284 5/17155 Meno I'm: Dennis M. Cutilfield, AD for Septy Amount, DL Threes M. Novak, AD for Lieming, "AL Much required from RB From: L.S. Ruberstein, AD for Care and Plant Systems + DSI Subject: Final Dreft of the River Band Unit I Technest Specifications In response to your animorandum dated A pul 19, 1985, The Power Systems Brand her reviewed these sections of the River Bend Unit 1 Technice specifications which are in the Auren Systems Branch aren of regione bility. The section reviewed by PSB are: I tem D in Tables 3.3.3-1, 3.3.3-2, and 4.3.3.1-1; Sector 3/4.2.8, Section 3/4.8, and Section B 3/4.8_ PSB. comments are from ded in the enclosed marked of fages of the River Bend taknic of splitting. Because some usings are still undergoing serolution with the applicant, partime of the River Bend taknice of afficienting may require additional changes at a loter cc R. Burners M. Similar J.E. Knight A. Ungar D. Houton J. Lageneek 13 Tomlinson Contart: J. Lopined × 2943 13 Tomberon x 29420 B/III

RIVER BEND - UNIT 1

FINAL DRAFT

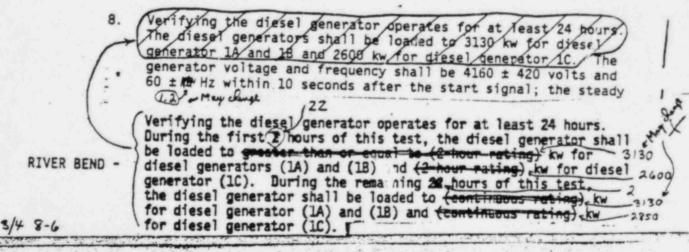
The may change defining on fined work thing of TOI integ For division III:
